**APPLICATION FOR RESOURCE CONSENT RMA/2023/597
ADDRESS 130 BOWENVALE AVENUE**

Thank you for your application for resource consent for 35 lot fee simple subdivision on the above site, which we received on 11th April 2023.

Figure 2-11: Proposed Road 1 Cross-Section

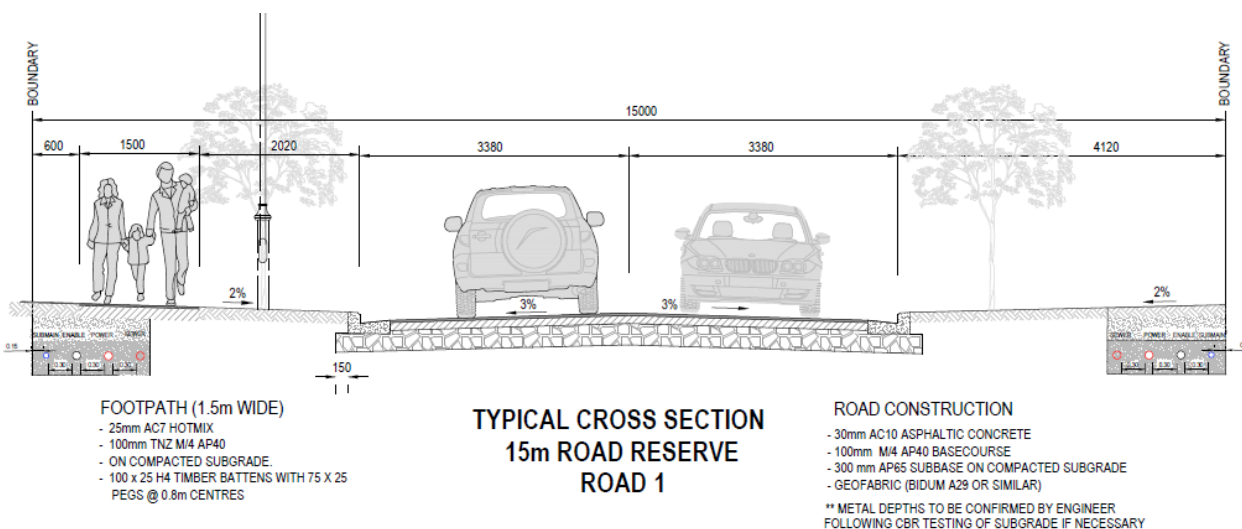
Road 1 is proposed with an approximately 6.7m wide carriageway, as shown in **Figure 2-11**. The adoption of a narrow carriageway is supported from a road safety perspective as it will encourage slow vehicle speeds. It is noted that a narrower 6m width could be adopted and still achieve two-way vehicle movement.
